Amendment Notice 1

Licence Number	L5258/1991/11
Licence Holder	Pilbara Iron Company (Services) Pty Ltd
ACN	107 210 248
Registered business address	Level 22, Central Park 152-158 St Georges Terrace PERTH WA 6000
Date of amendment	18 October 2016
Prescribed Premises	Category 5: Processing of beneficiation of metallic or non-metallic ore; Category 6: Mine dewatering; Category 12: Screening, etc. of material; Category 54: Sewage facility; Category 64: Class II putrescible landfill site; Category 73: Bulk storage of chemicals, etc
Premises	Mount Brockman, Nammuldi and Silvergrass Iron Ore Mines AML70/4, ALM70/272, G47/01242, G47/01243, L47/140, L47/388, L47/141, L47/647, LGE G848898, LG848907 and LPL N050438 within co-ordinates: E535363 N7536177; E 544071 N7257202; E553417 N7525629; E548757 N7517535; E538693 N7517627; E531400 N7517644; E527723 N7519096 and E525753 N7531802. MT SHEILA WA 6751

On 4 August 2016 (and resubmitted on 9 August 2016) Pilbara Iron Company (Services) Pty Ltd (Licence Holder) submitted an application to DER for an amendment to the Mt Brockman and Nammuldi Iron Ore Mines licence (L5258/1991/11). The licence amendment application relates to the proposed constructi

Attachment 6 – Primary Crusher and conveyor

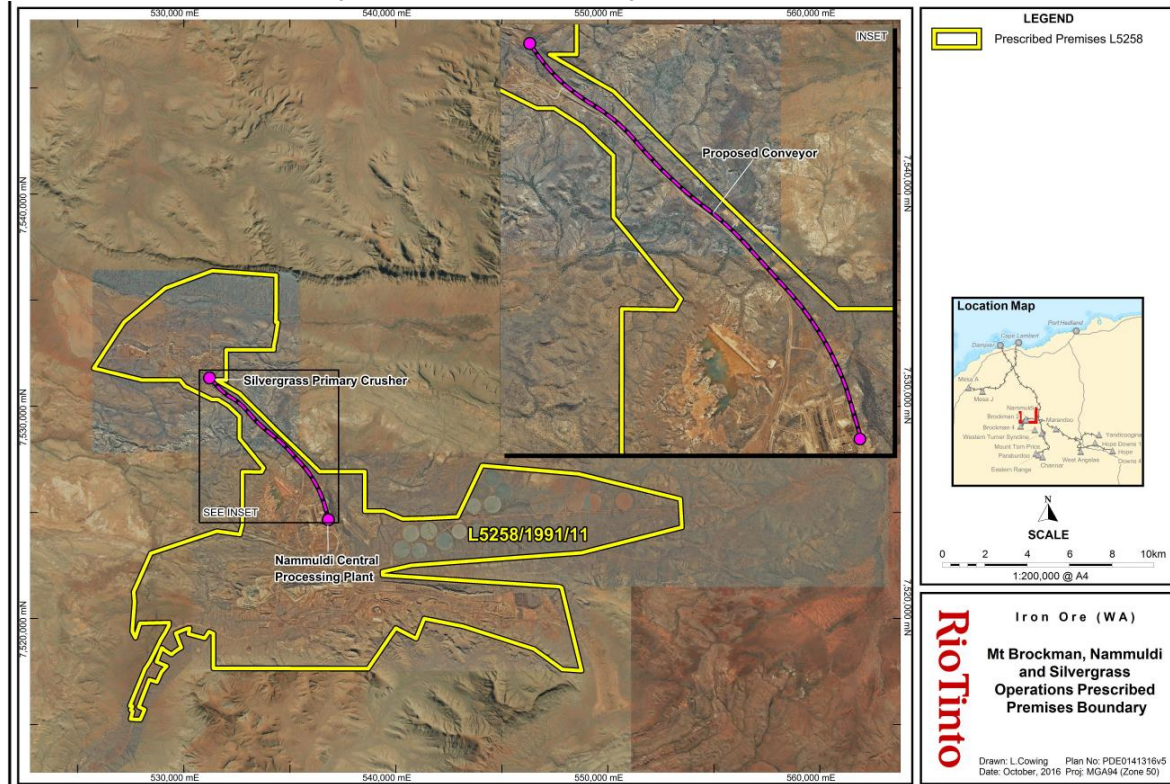
7. Attachment 6 to be added to the licence as below:

Table 3: Infrastructure Requirements Table		
Column 1	Column 2	Column 3
Infrastructure	Location	Requirements (design and construction)
Conveyor (linking SGE to Nammuldi) and Primary Crusher	Conveyor as highlighted pink on Attachment 6 SGE Primary Crusher as highlighted pink on Attachment 6	<ol style="list-style-type: none"> 1. Primary Crusher (containing run of mine bin, vibrating grizzly and primary crusher) - Constructed to ensure clean stormwater and potential sediment load run-off are separated. Proposed grading of the site and creation of earthen drain to divert clean stormwater away from the primary crusher (Attachment 9, Figure 1) 2. Primary Crusher - Earthen sedimentation / silt pond indicatively designed to contain a peak 1:10 year average recurrence interval (Attachment 9, Figure 3) 3. Graded site to direct clean stormwater away from conveyor 4. Primary Crusher – Sediment sumps (indicative capacity of 22m³ each), one concrete drive-in sump to be constructed within Primary Crushing facility (Attachment 9, Figure 1) and second at nearby transfer station, to allow capture and settling of sediment laden water from the process or washdown

Attachment 8 – Silvergrass East Waste Dump Landfill

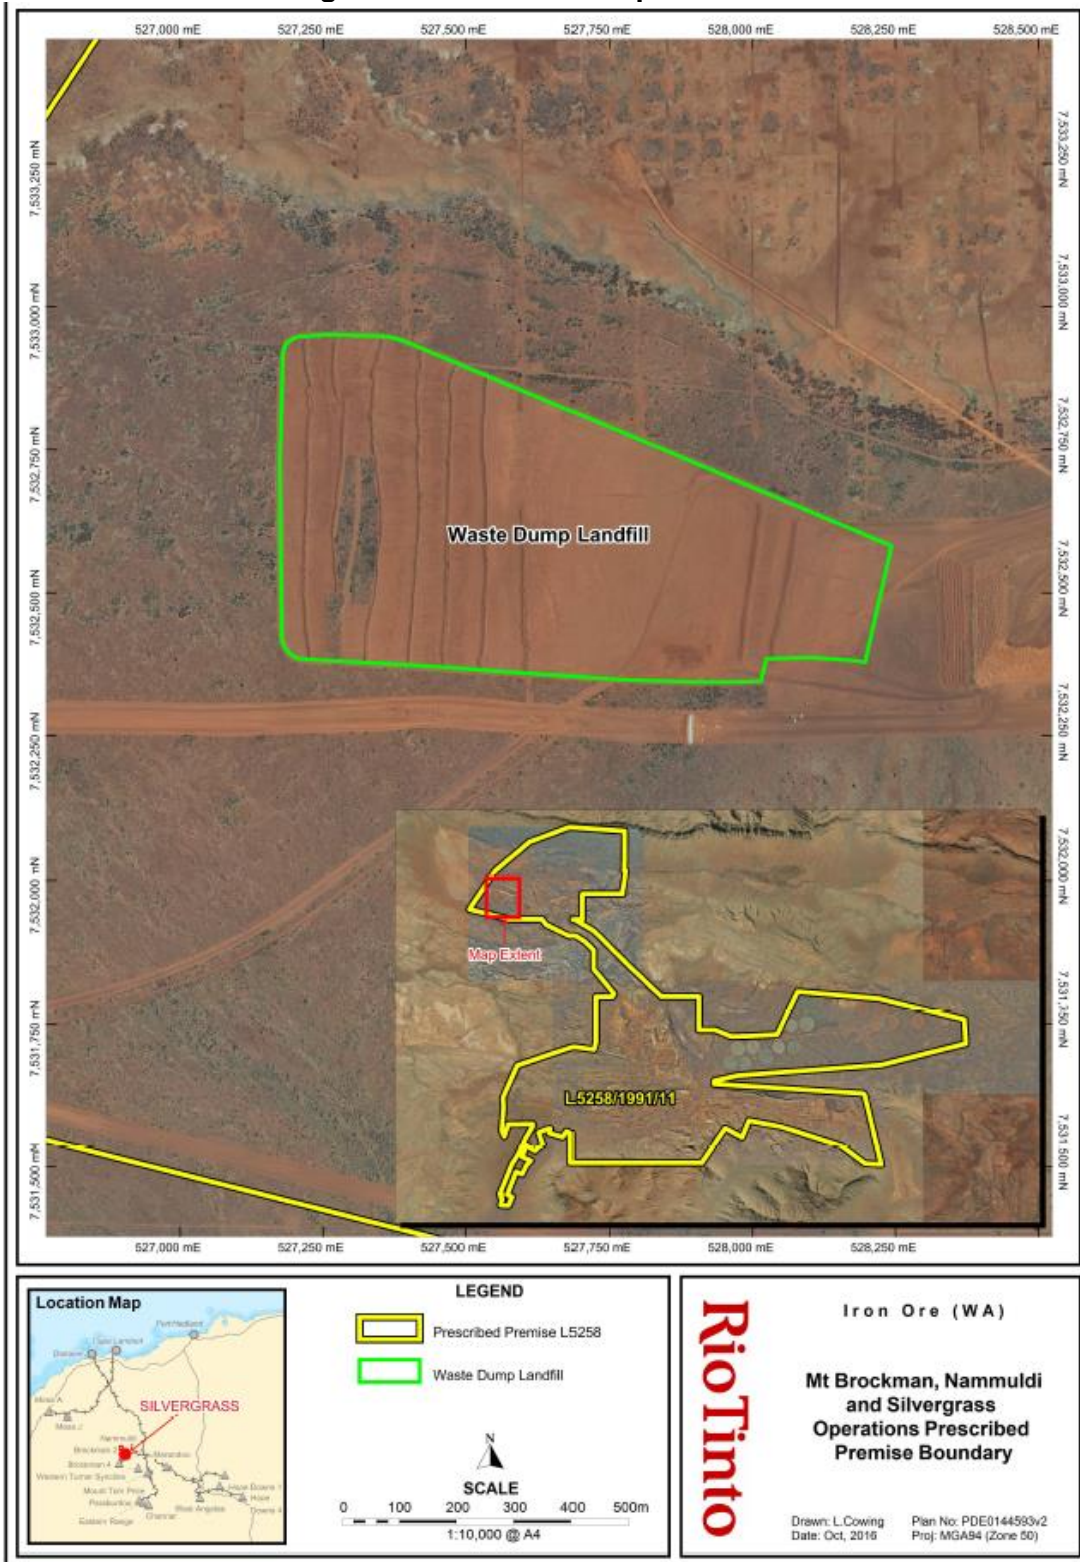
MANAGEMENT OF WASTE DUMP LANDFILL (ATTACHMENTS 5 AND ATTACHMENT 8)

The Licensee shall bury the following types of waste within the waste dump landfill facility:

- (i) Clean Fill as defined in the Landfill Definitions;
- (ii) Inert Waste Type 1 as defined in the Landfill Definitions;
- (iii) Inert Waste Type 2 (tyres only) as defined in the Landfill Definitions; and
- (iv) Wooden pallets.
~~as defined in the Landfill definitions.~~

Figure 1 – Preliminary design figure depicting indicative sump location and capacity at the Primary Crusher

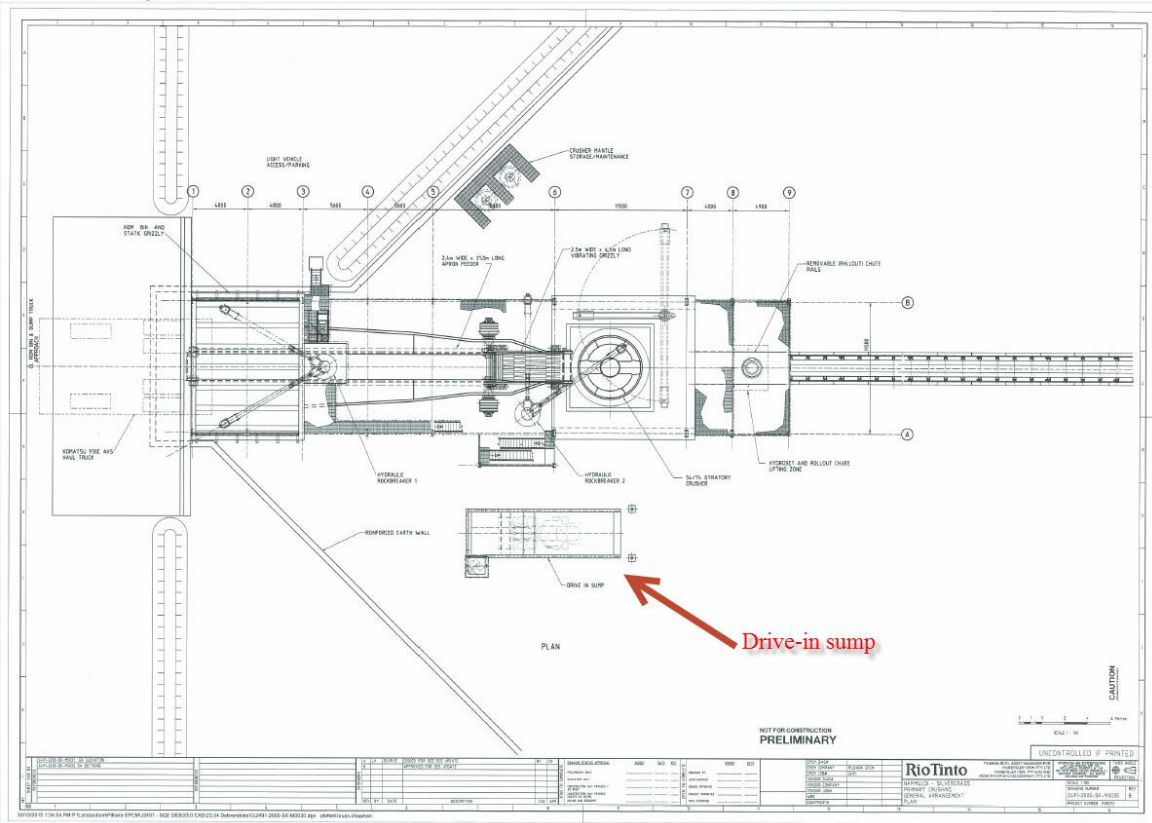
- (a) Process plants;
- (b) Washdown bays;
- (c) Refuelling areas;
- (d) Mechanical workshops.
- (e) Primary crushing plant shown in Attachment 9 as Figure 1; and
- (f) Fuel Storage Facility shown in Attachment 9 as Figure 2.

- (a) Process plants;
- (b) Maintenance workshops;
- (c) Laboratory;
- (d) Primary crushing plant shown in Attachment 9 as Figure 1;
- (e) Fuel Storage Facility shown in Attachment 9 as Figure 2; and
- (f) Power generation areas.
